The Town of Hilton Head Island Regular Design Review Board Meeting

AGENDA

DESIGN TEAM/ DRB COMMENT SHEET

PROJECT Reilley's South DRB# DR100035

Sheet Title:
COVER SHEET:
PERMIT INFORMATION
PROJECT NARRATIVE

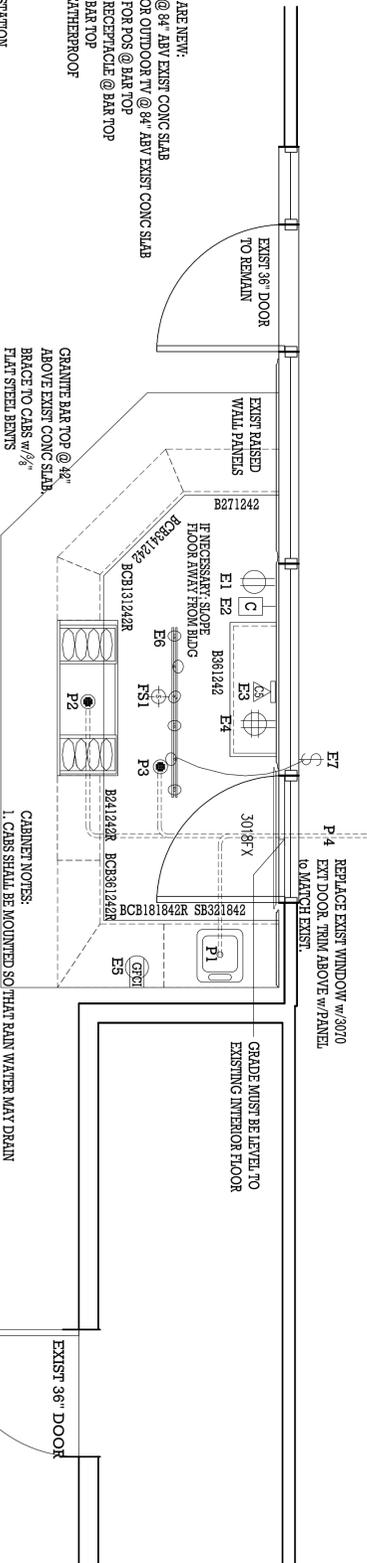
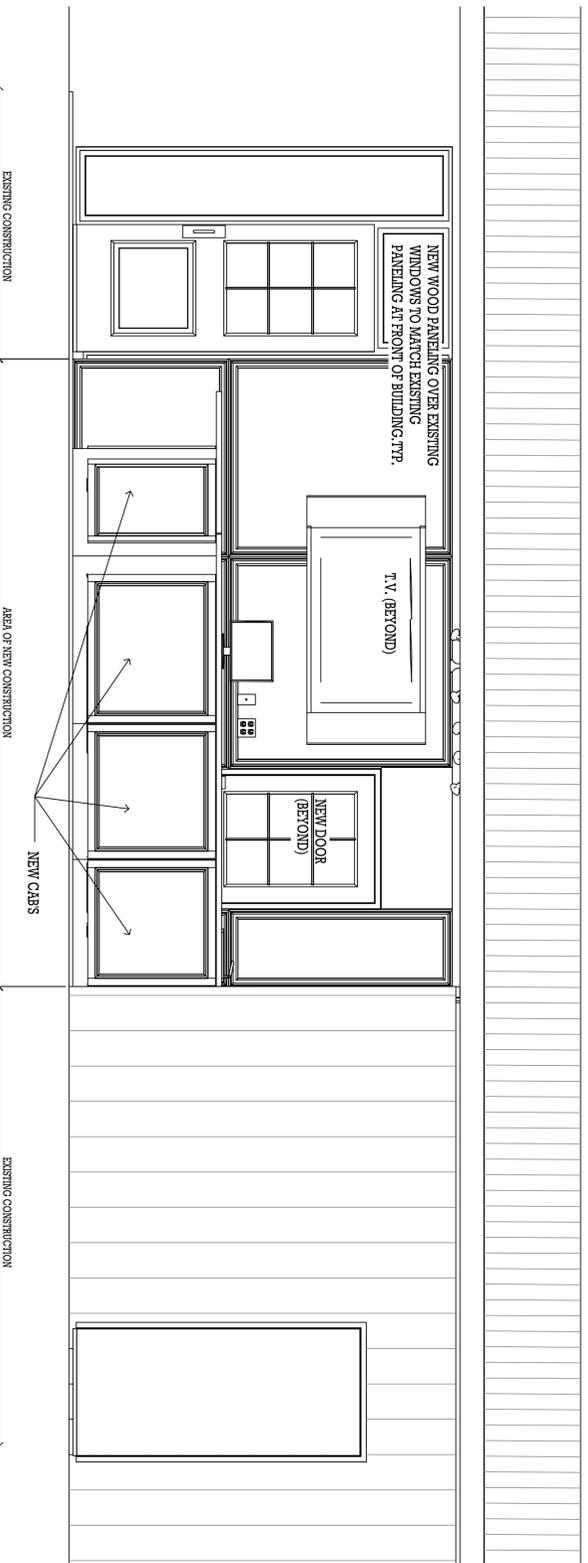
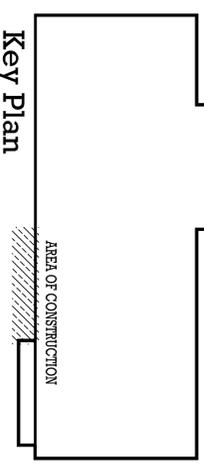
ARCHITECTURAL DESIGN		
Drawings call for existing door to remain, but elevations show a door with muntins in its place, which also matches the proposed door behind the bar. Some clarification is needed, and Staff would recommend that all doors on all sides should match. Staff would also request that all lighting above the bar should be recessed in the soffit, or otherwise concealed.		
DESIGN GUIDE/LMO CRITERIA	COMPLIES YES/NO/N/A	COMMENTS OR CONDITIONS
Structure is designed to be appropriate to the neighborhood		
Promotes pedestrian scale and circulation		
Design is unobtrusive and set into the natural environment		
Utilizes natural materials and colors		
Avoids distinctive vernacular styles		
Design is appropriate for its use		
All facades are have equal design characteristics		
Avoids monotonous planes or unrelieved repetition		
Has a strong roof form with enough variety to provide visual interest

POST & BEAM ASSEMBLY DETAIL

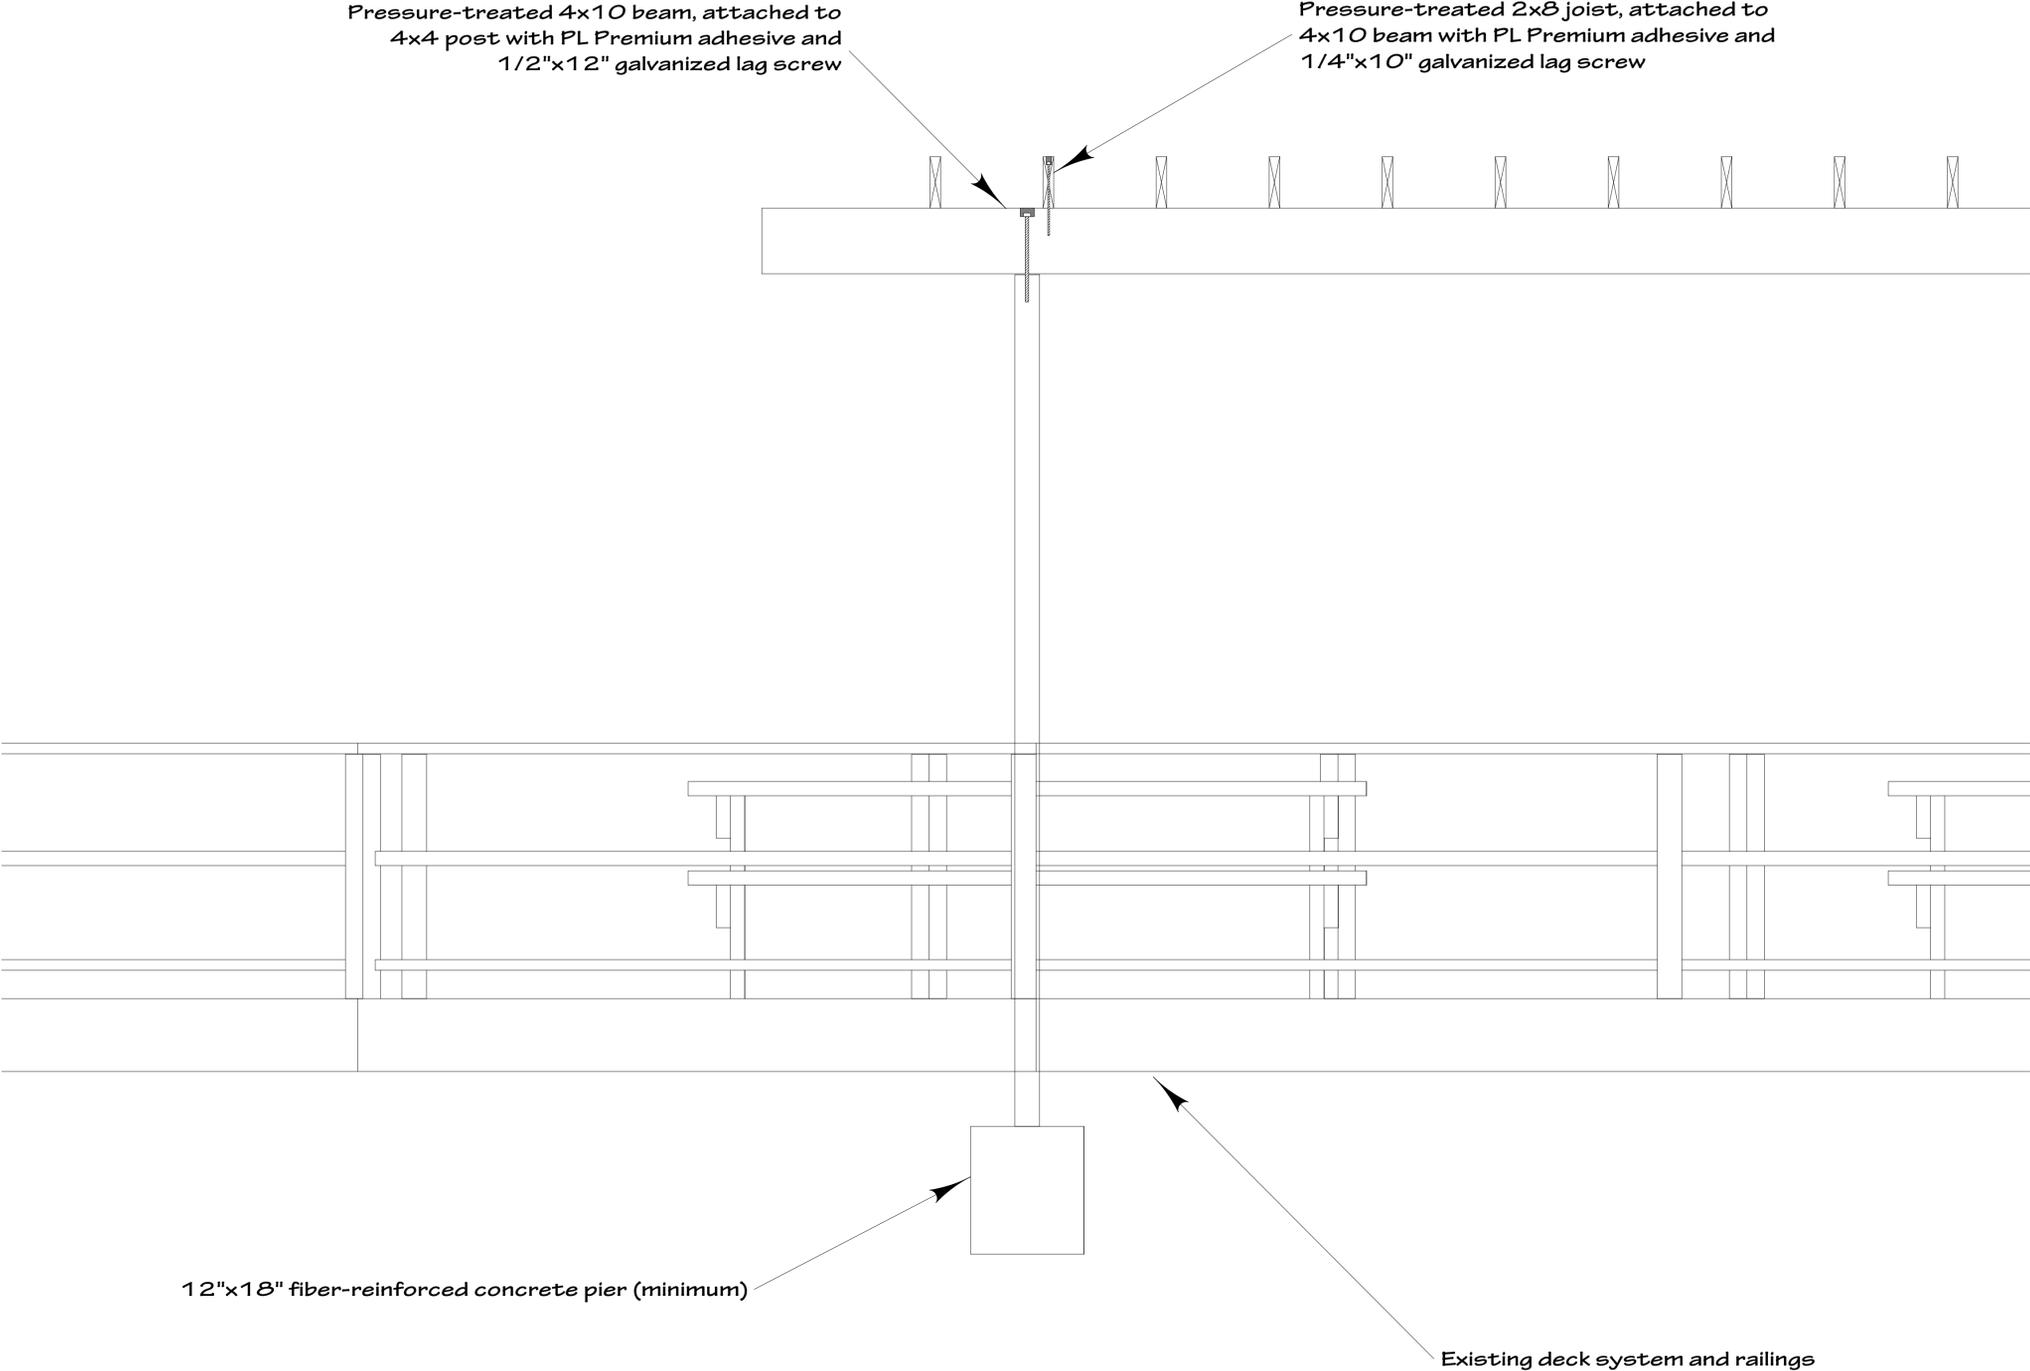
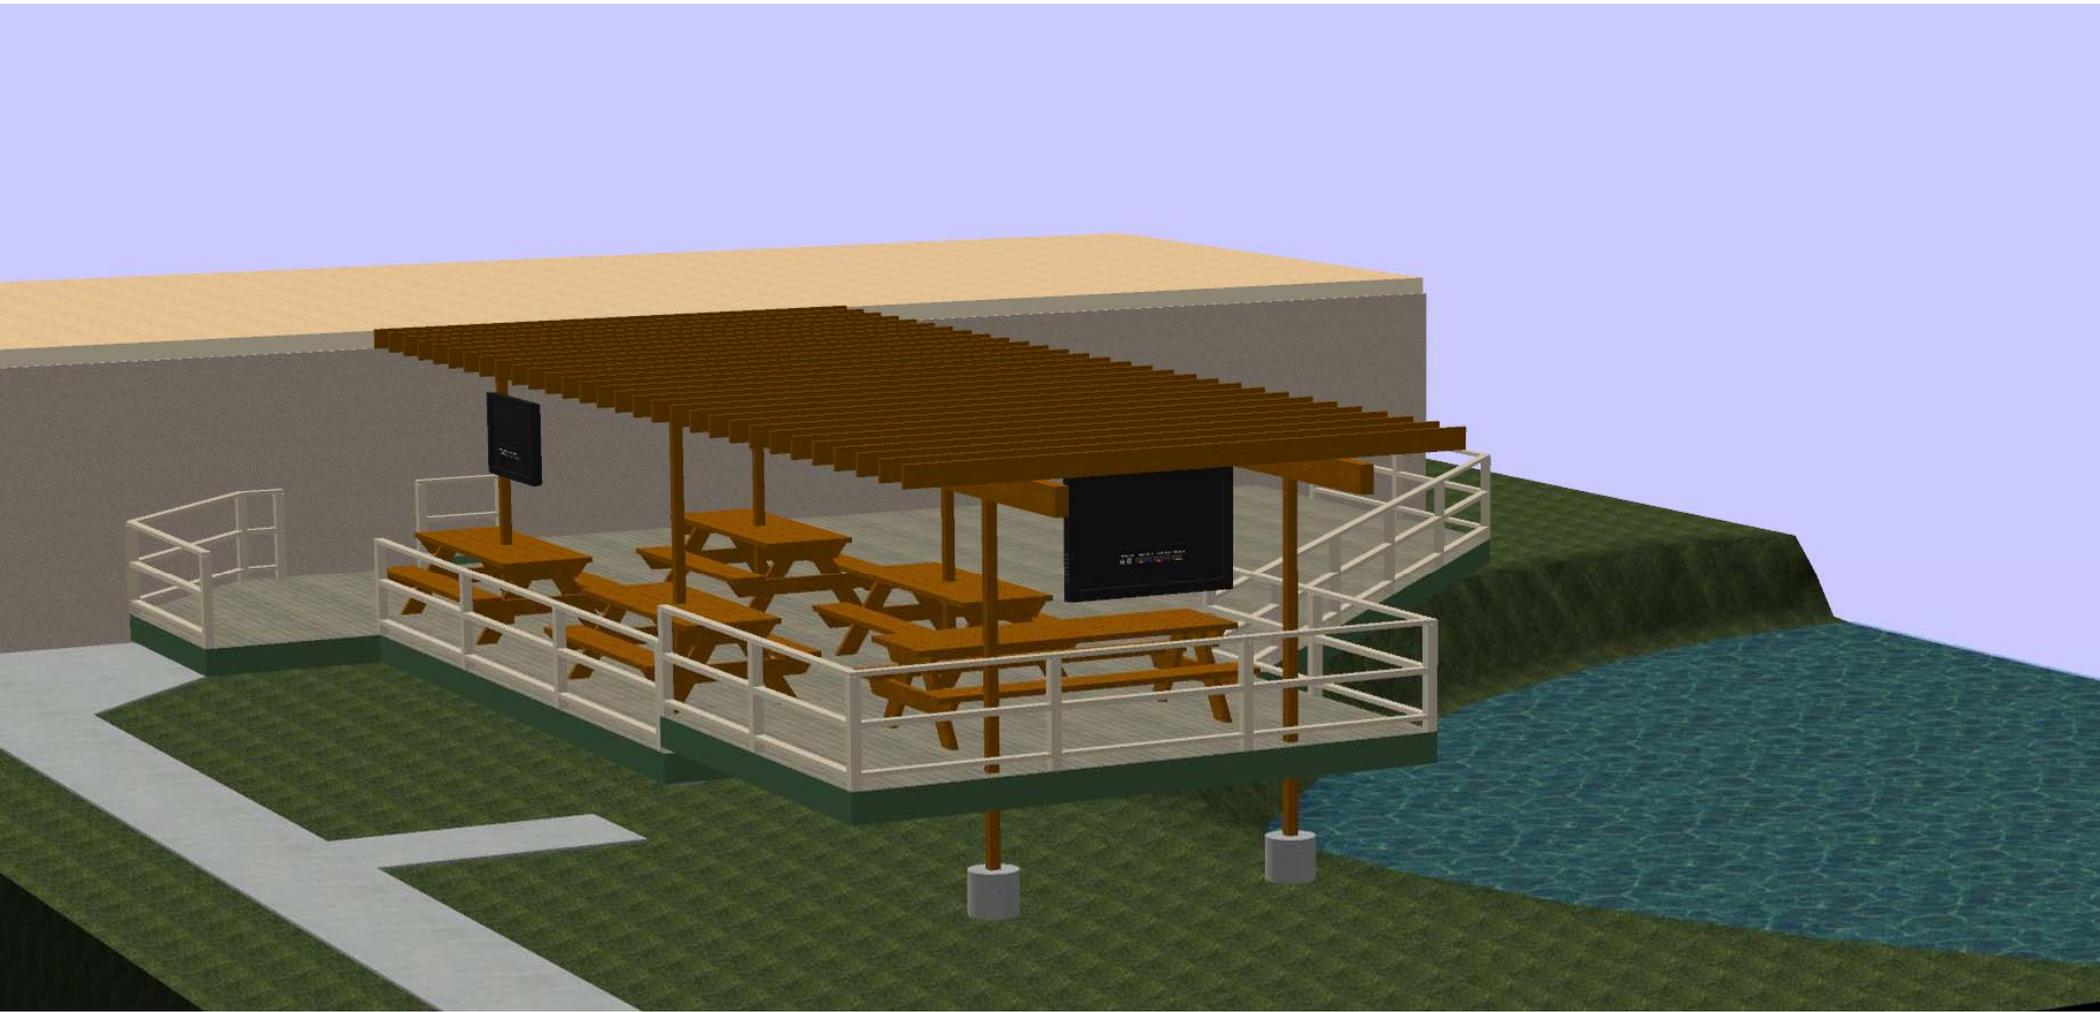
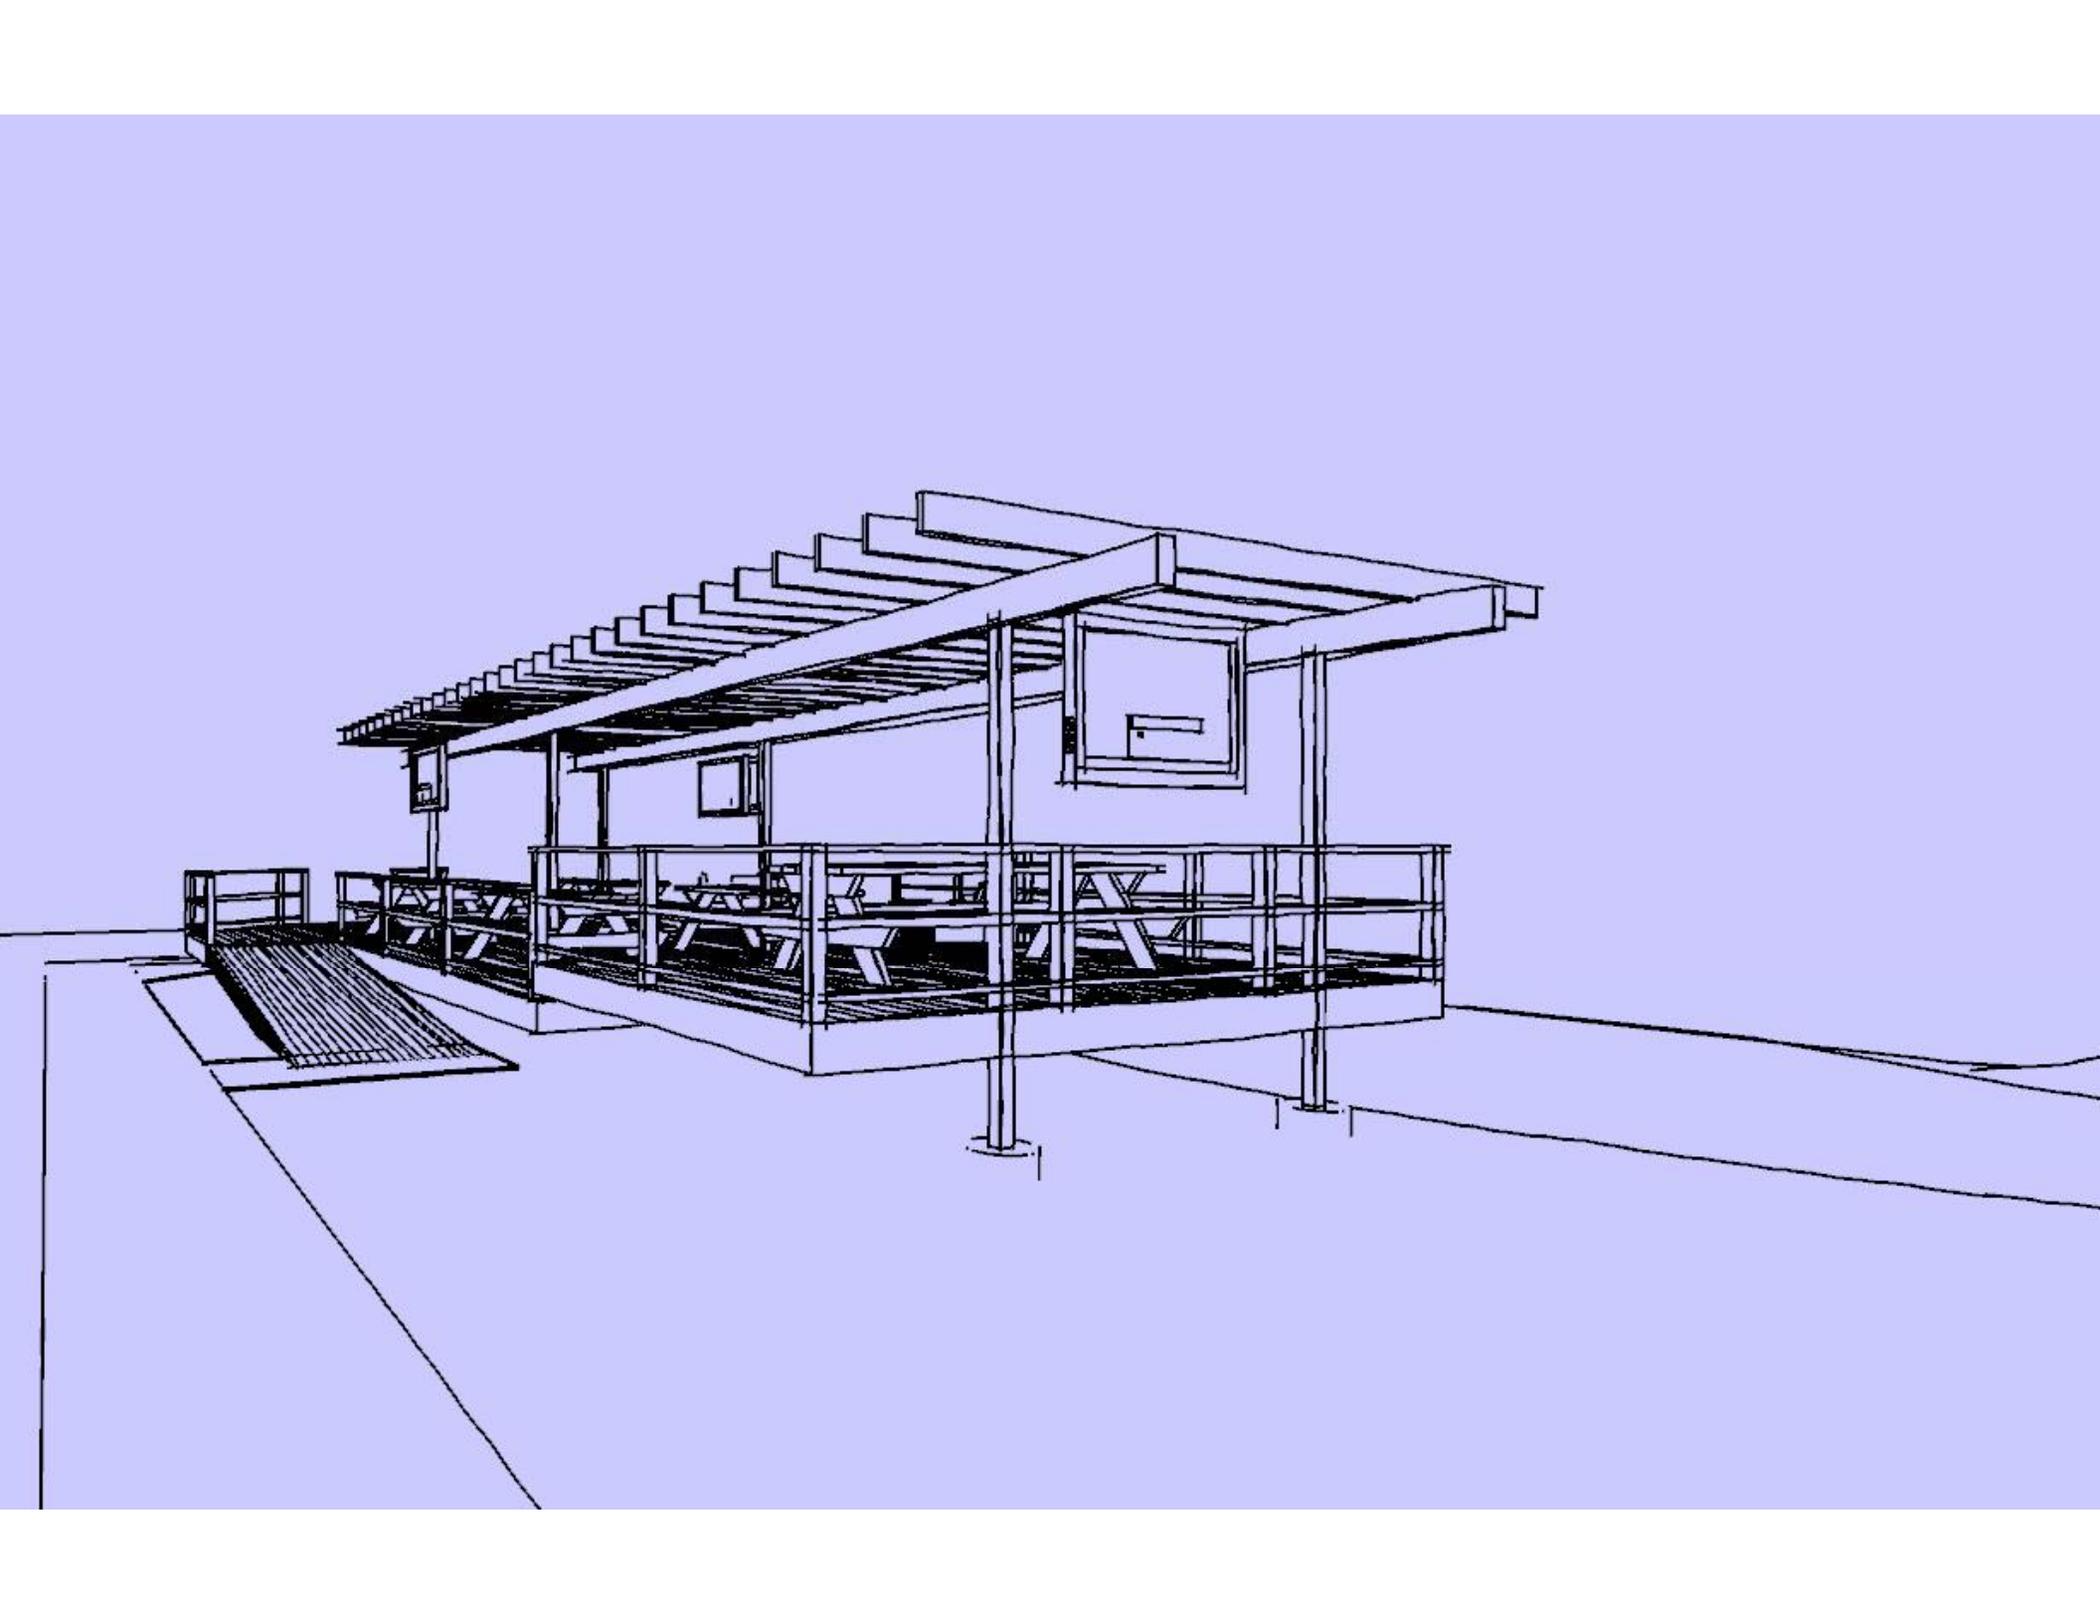
ARCHITECTURAL DESIGN
 Post/beam proportions might be discussed, but overall an approvable addition to an existing deck. Some form of detail at the ends of the horizontal elements might soften the overall feel of the structure.

DESIGN GUIDE/LMO CRITERIA	COMPLIES YES/NO/NA	COMMENTS OR CONDITIONS
An effort has been made to preserve existing trees and under story plants		The edge of the pergola must not be close enough to the large pine at the corner of the existing deck to be hit by the pine when it sways in the wind. Pergola supports must be at least 6 feet from the base of the pine.
Supplemental and replacement trees meet LMO requirements for size, species and number		
Wetlands if present are avoided and the required buffers are maintained		
Sand dunes if present are not disturbed
